Before the  
**FEDERAL COMMUNICATIONS COMMISSION**  
Washington, D.C. 20554

In the Matter of	)	
	)	
Viasat, Inc.	)	Callsign S2985
	)	File No. SAT-MPL-20200526-00056
Application to Modify	)	
NGSO System Authorization	)	
	)

**REPLY OF TELESAT CANADA**

**Figure 1**

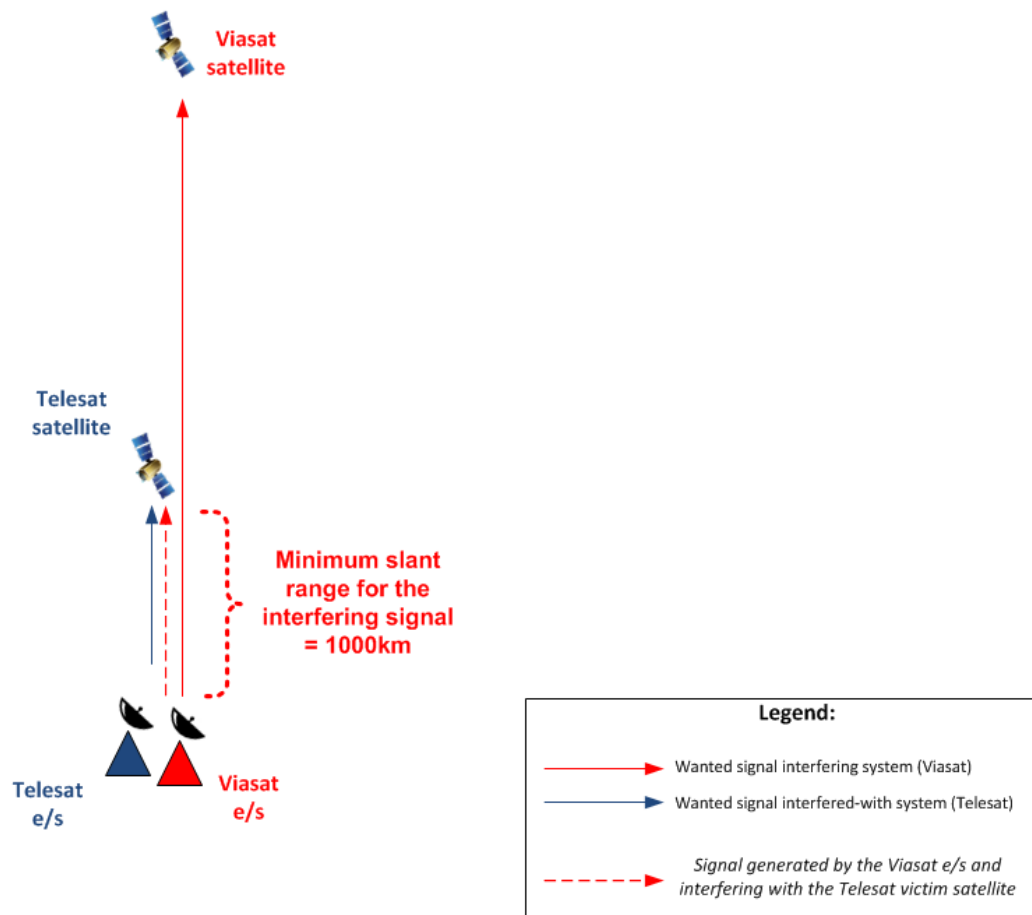
### **I. VIASAT IS CONFUSED ABOUT WHICH MINIMUM SLANT RANGE SHOULD BE USED IN A WORST-CASE STATIC ANALYSIS OF SCENARIO 2 (UPLINK, VIASAT AS THE INTERFERER)**

Viasat claims that Telesat has failed to identify “discrepancies” between Viasat’s EIRP data and its I/N plots. To support such claim, Viasat states that Telesat is not modelling the Viasat system correctly, as it uses, in Tables A2-1a and A2-1b of the Telesat petition, a minimum slant range of 1,000 km. Viasat asserts that, instead, Telesat should use a minimum slant range of 8,200 km or 1,300 km, which are the orbit altitudes of the Viasat system *before* and *after* the proposed modification, respectively. Viasat seems confused with respect to the basic assumptions that should be made when assessing the interference environment in a worst-case static analysis of “Scenario 2” (i.e., when Viasat is the interferer in the uplink direction). This scenario evaluates the interference from a Viasat uplink into a Telesat satellite in a geometry where one satellite for each of the Telesat and Viasat systems are exactly above the collocated earth stations of those systems and point the boresight of one of their beams in that same direction. In such scenario, 1,000km is the correct slant range to use in the calculation because it is the distance from the Viasat uplink to the satellite of the Telesat constellation, which is where the interference is being measured in this Scenario. Correspondingly, in this scenario, the distance to the Viasat satellite is irrelevant. This geometry can be easily illustrated in Figure 1 below. Furthermore, in order to avoid any further confusion, Telesat is pleased to clarify some of the terms used in Tables A2-

1a and A2-1b of its Petition. The tables from Telesat's Petition are reproduced below, however a new column "Parameter (clarified wording)" has been added. Telesat trusts that with these clarifications, Viasat confusion on this basic analysis is removed.

**Illustration of a worst-case static analysis of Scenario 2 (Uplink, Viasat as Interferer)**
